A REPAIR

SEWAGE DISPOSAL SYSTEM

MARYLAND STATE DEPARTMENT OF HEALTH

PROPERTY OWNER Mr. Main

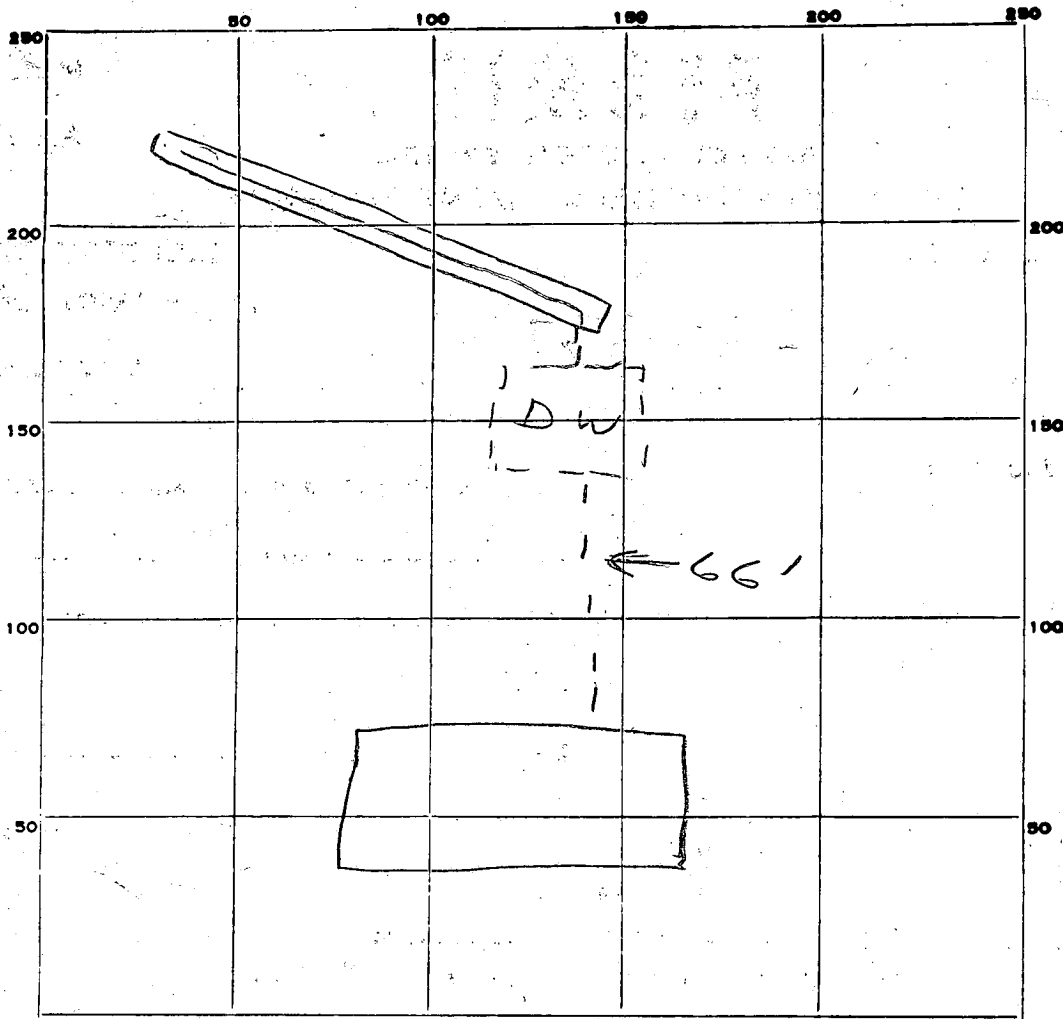
**REPAIR - CALL FOR INSPECTION WHEN GROUND IS OPENED UP SO SANITARIAN CAN RECOMMEND REPAIR.**

*Trench 65 ft long - 14 ft deep - 6 ft stone under pipe - owner to give statement re depth of trench. Stayer*

REMARKS 5/20/80 OK to cover all work. JS
